STATE OF NORTH CAROLINA
DEPARTMENT OF TRANSPORTATION

Subject: Modification Request for the Individual Section 404 Permit, Individual Water Quality Certification, and Tar-Pamilico Buffer Authorization for the Rocky Mount Northern Connector, from SR 1604 (Hunter Hill Road) to US 301, Nash County, TIP No. R-2823, Debit \$570 from WBS 34509.1.1.

In an application dated December 17, 2008, the North Carolina Department of Transportation (NCDOT) submitted an Individual Permit application for the Subject project. This application requested authorization for impacts to jurisdictional features based upon a final design prior to an additional public meeting presenting the final design, held on October 28, 2008. Based upon comments from the meeting and subsequent inquiries from the public concerning the traffic flow from Station -L- 27+45 to Station 65+55, the roadway was re-designed to include directional crossovers and four bulb U-turns to provide additional left-turn traffic flow along Woodruff Road. The redesign will result in unavoidable impacts to Waters of the U.S. Revised permit drawings, buffer drawings and roadway plans are included with this modification request.

REVISED 06/11/09
PERMIT DRAWING
SHEET 7 OF 68

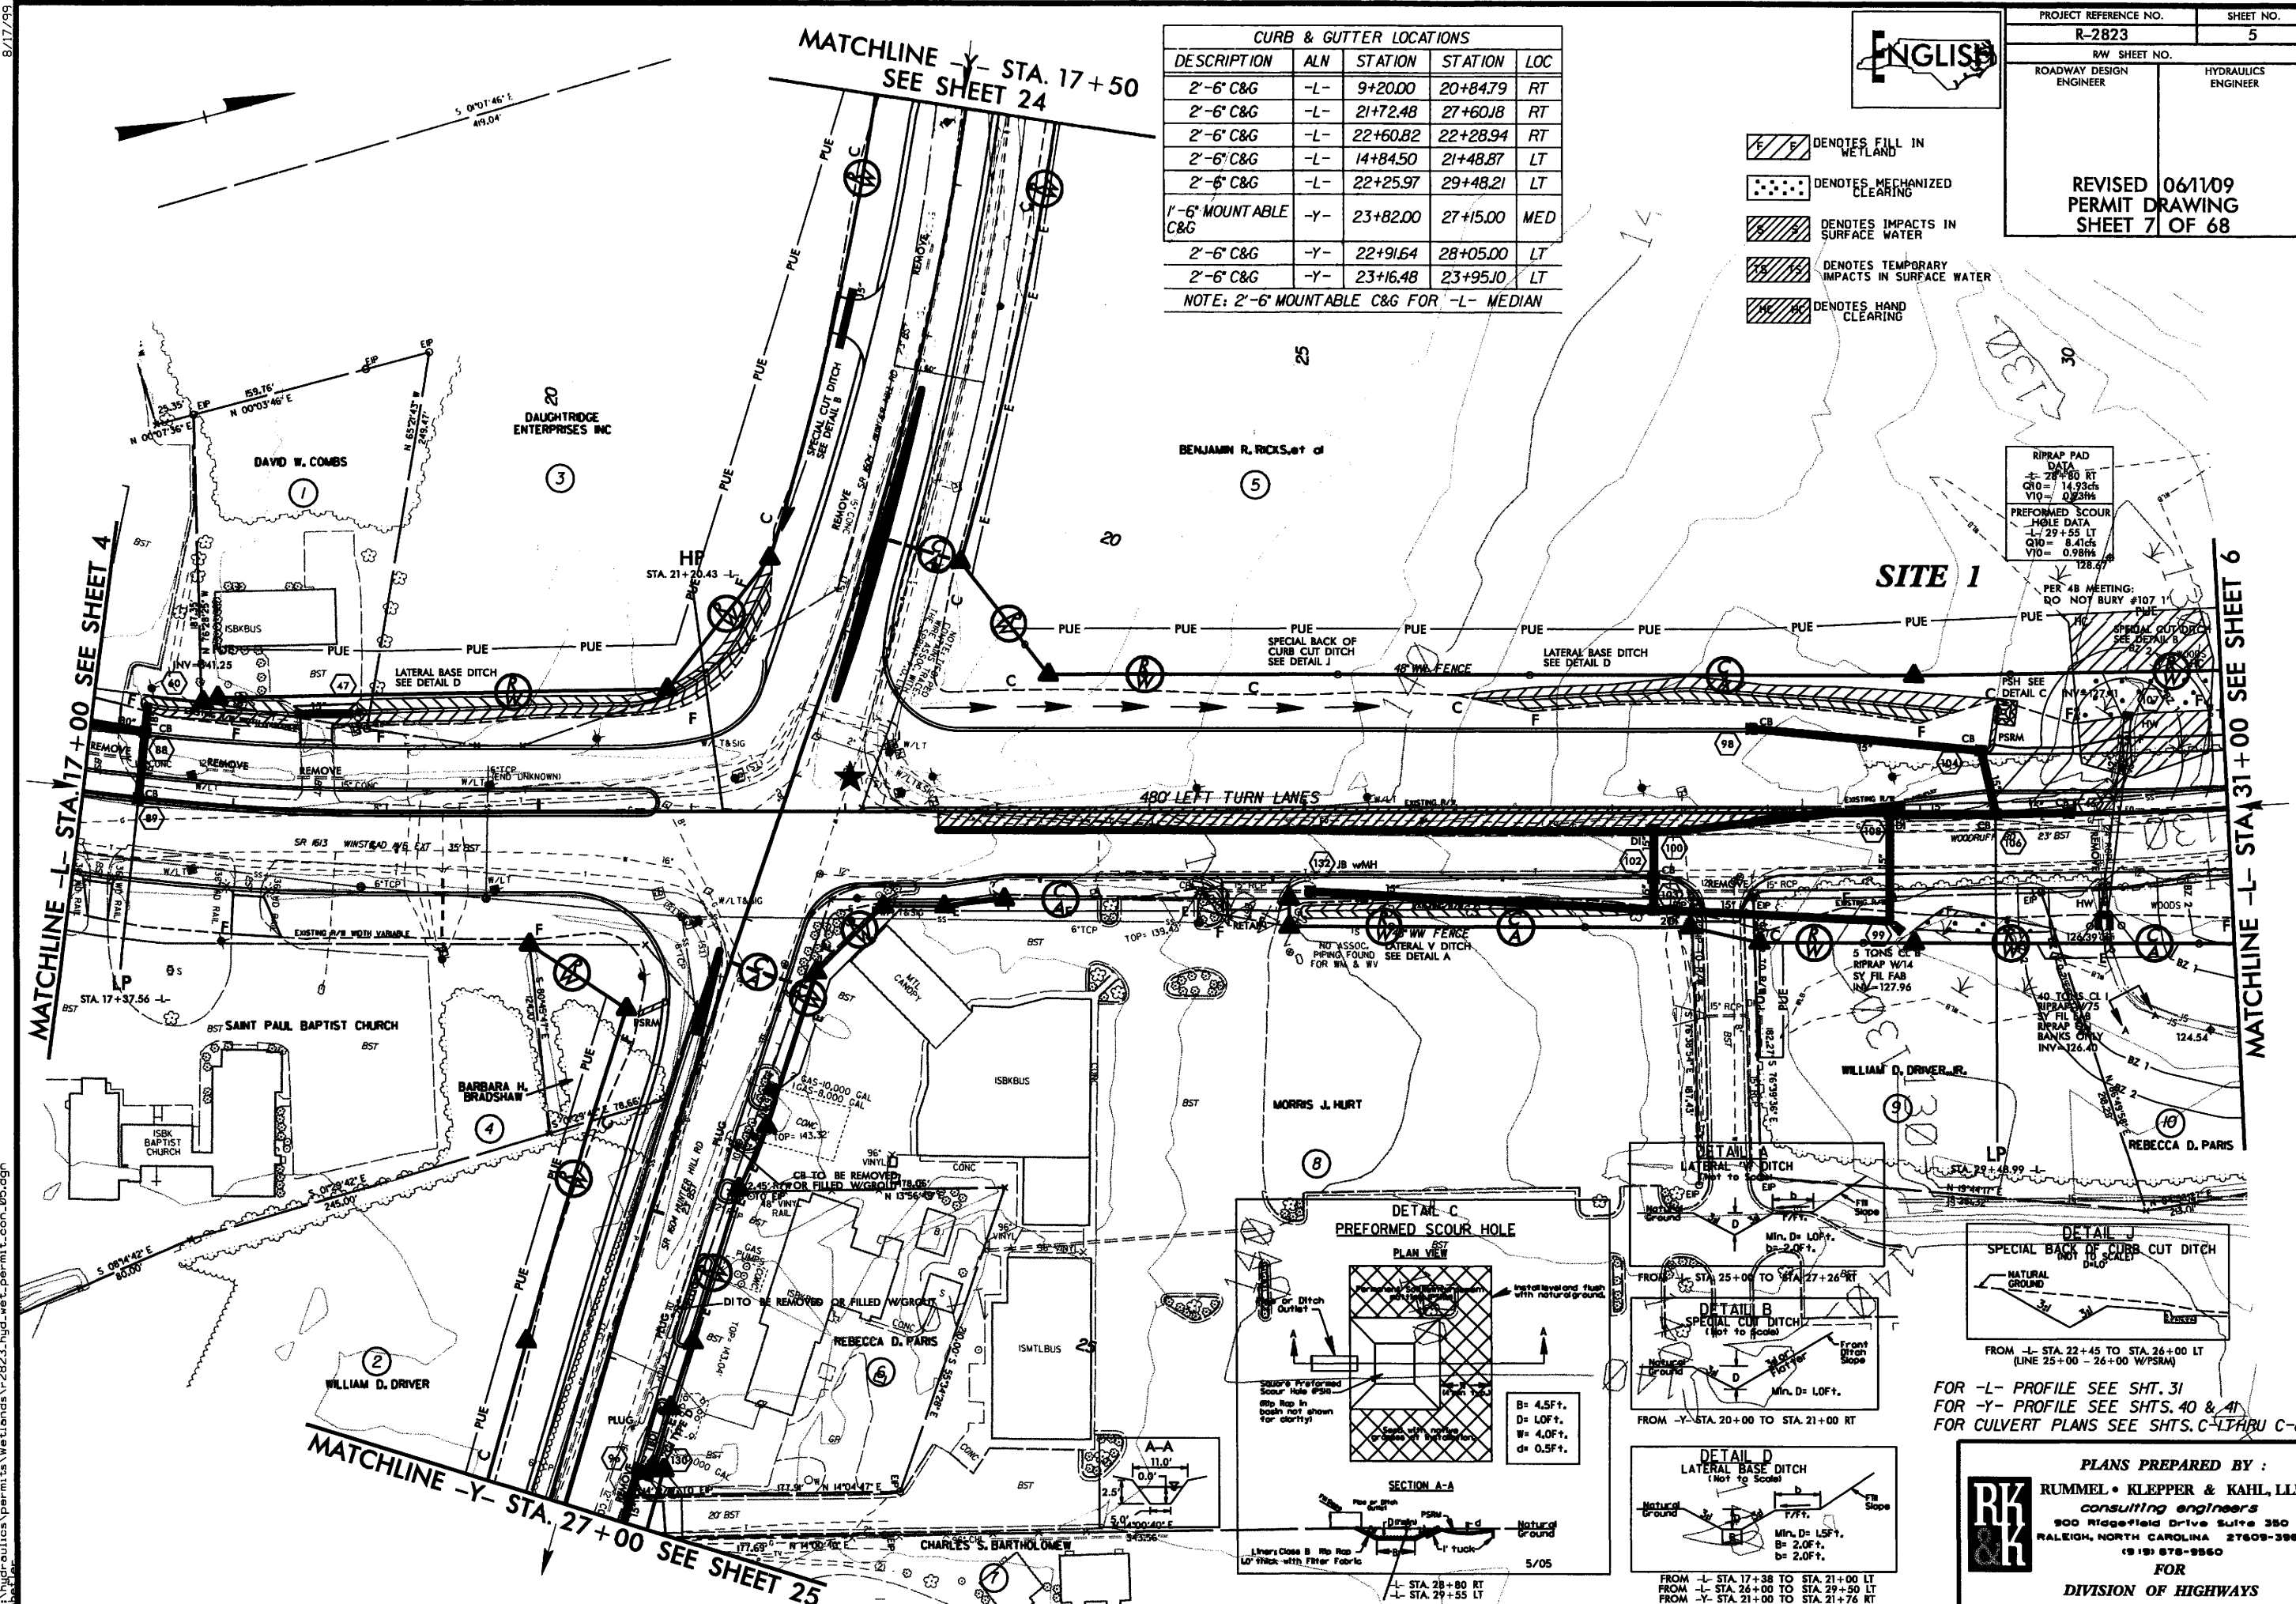
The revised drawings (Permit Sheets 7 and 8 of 68 and Buffer Sheets 7 and 8 of 56) indicate that impacts at Site 1 will change due to a new left-turn bulb added to the project as well as a pipe clearance profile change. Aerial utility lines in this area have resulted in hand clearing in wetlands and buffers (Zone 2). The bulb will allow vehicles from businesses near the Hunter Hill Road intersection and the residences on Goose Branch Drive to maintain enough distance between the cross streets for maneuvering across all lanes of traffic. A summary of the original and revised impacts is provided in the following table.

Impact Description	Dec. 17, 2008 Impact	Revised Impact	Impact Change
Fill in Wetlands	0.06 Ac	0.07 Ac	+0.01 Ac
Mech. Clearing in Wetlands	0.05 Ac	0.07 Ac	+0.02 Ac
Hand Clearing in Wetlands	0	0.08 Ac	+0.08 Ac
Perm. Surface Water Impacts	0.01 Ac (95 LF)	0.01 Ac (95 LF)	None
Temp. Surface Water Impacts	0.00 Ac (10 LF)	0.00 Ac (10 LF)	None
Wetlands in Buffer Zone 1	3,268 sq ft	3,279 sq ft	+11 sq ft
Wetlands in Buffer Zone 2	687 sq ft	2,585 sq ft	+1,898 sq ft
Allowable Buffer Zone 1	7,865 sq ft	7,922 sq ft	+57 sq ft
Allowable Buffer Zone 2	3,903 sq ft	6,271 sq ft	+2,368 sq ft

SITE 1
REVISED 06/11/09
PERMIT DRAWING
SHEET 9 OF 68

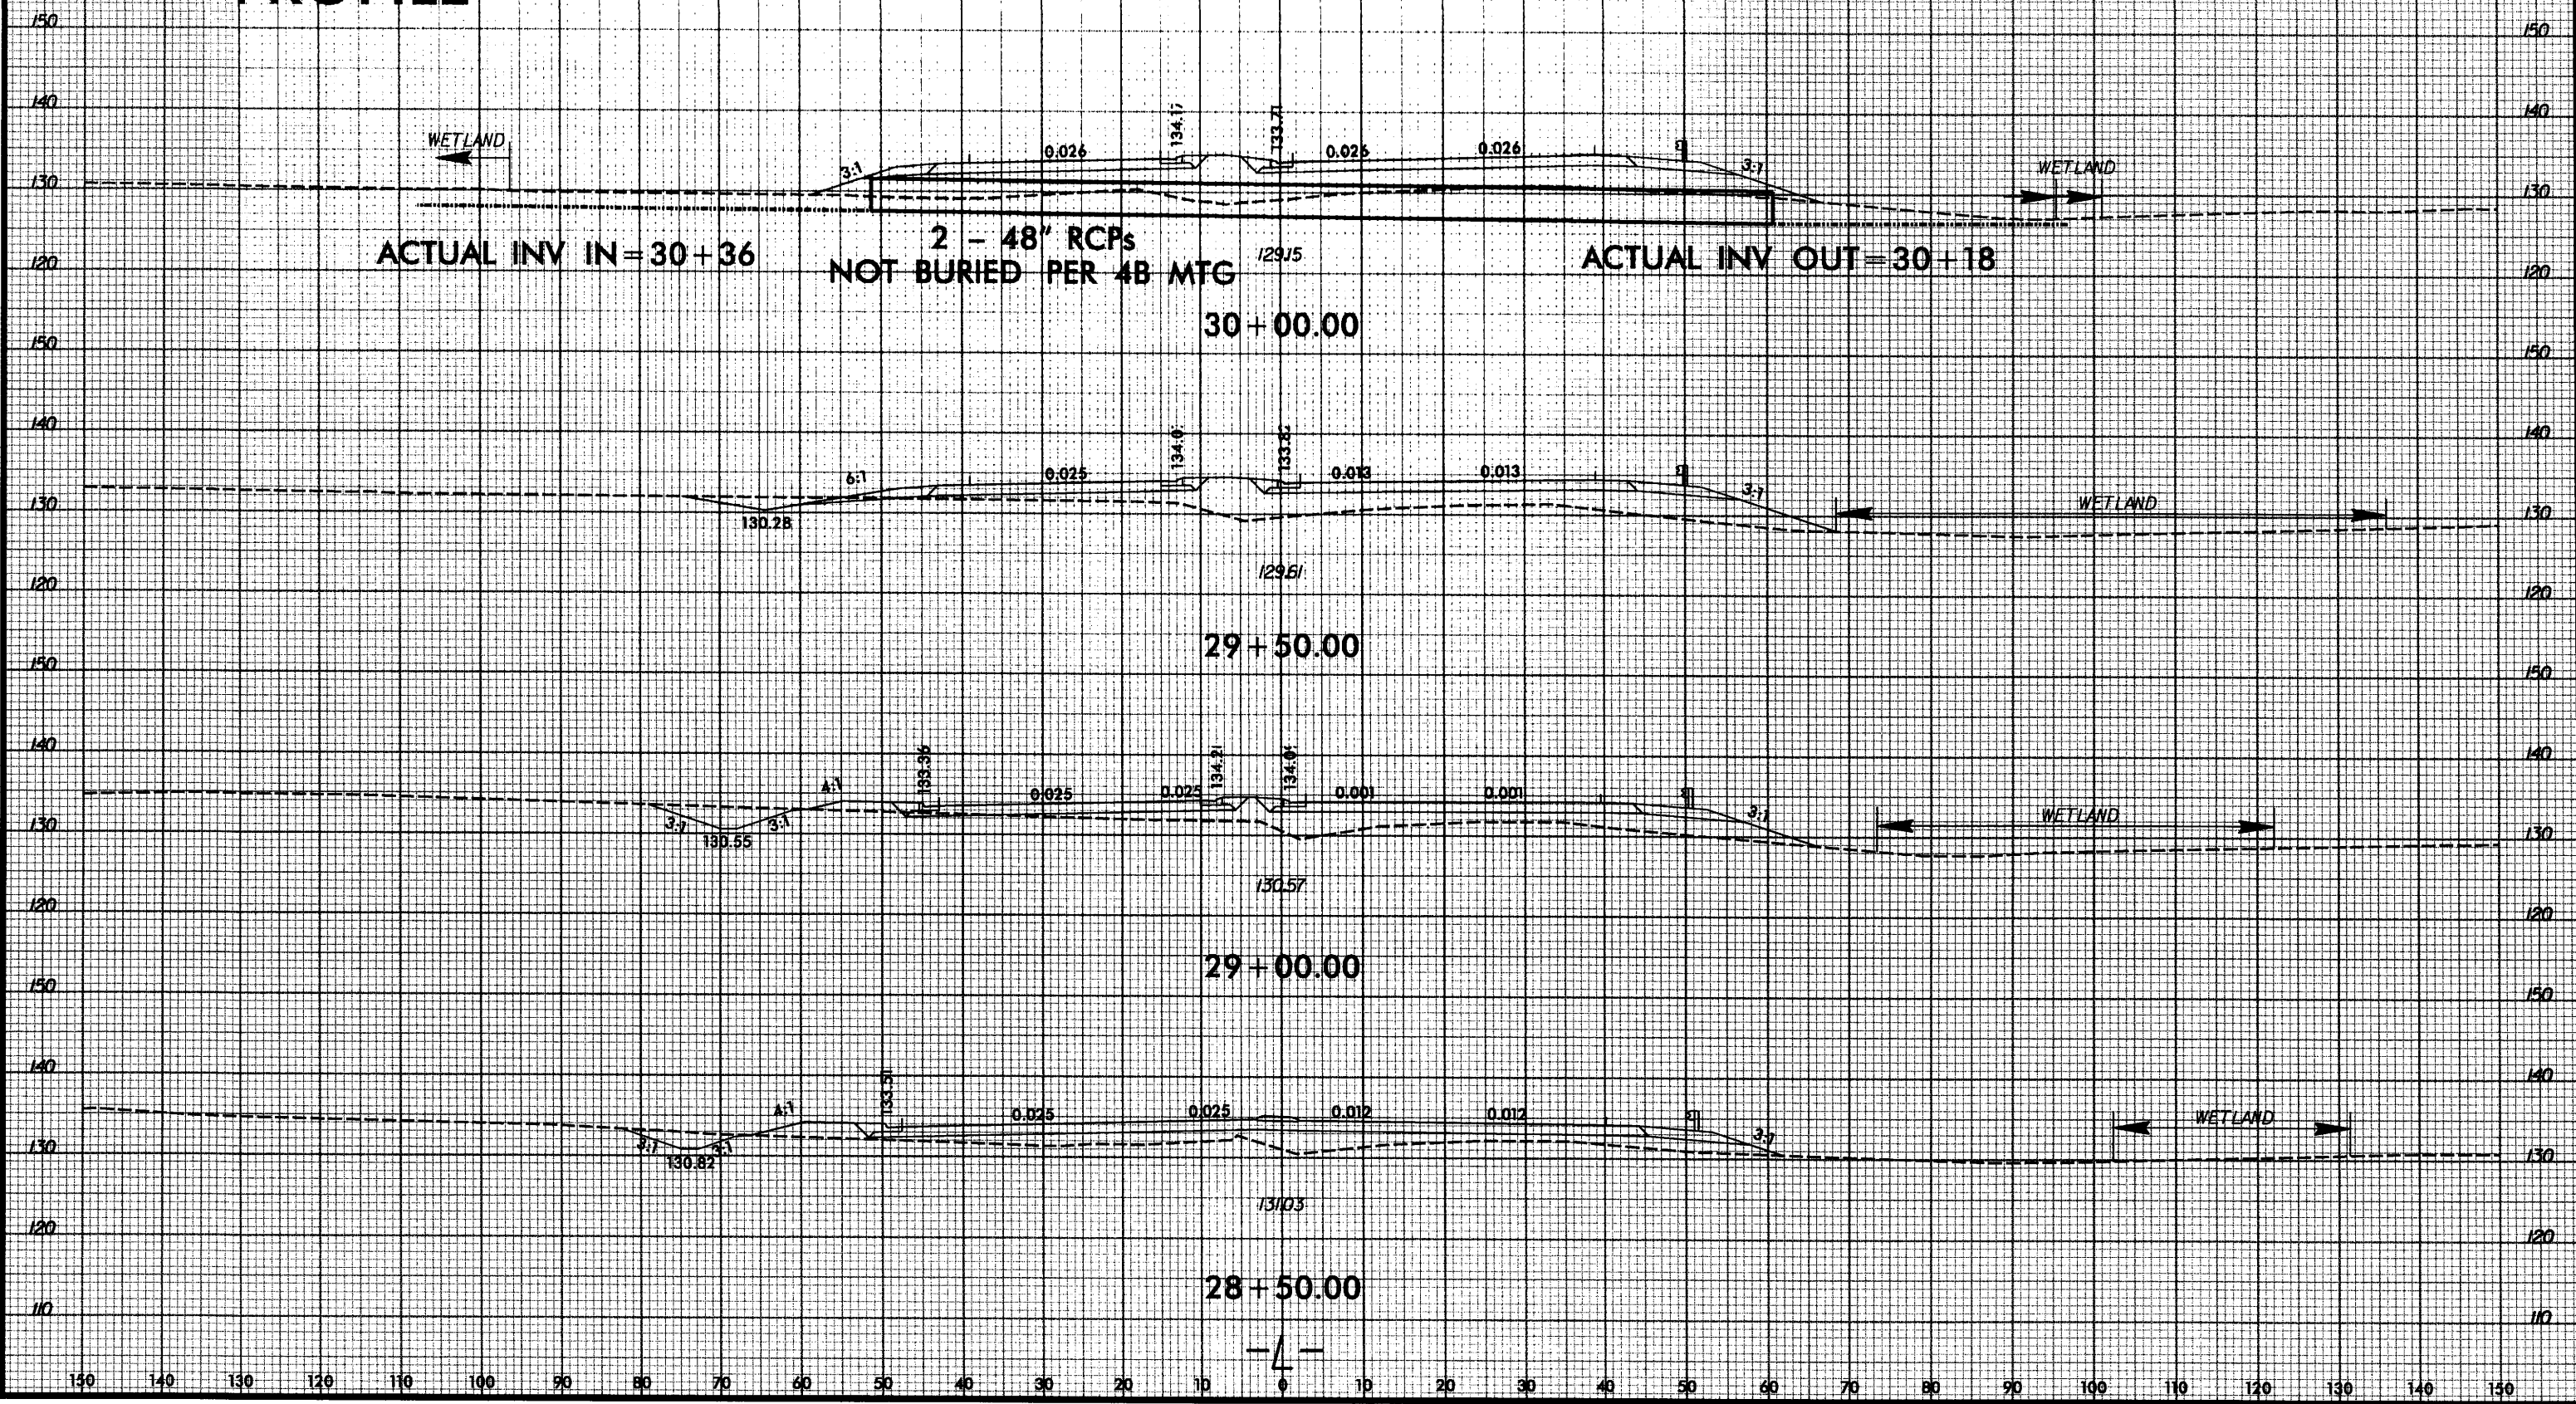
Revised cross section permit sheets 9 and 10 of 68 (buffer sheets 9 and 10 of 56) are enclosed.
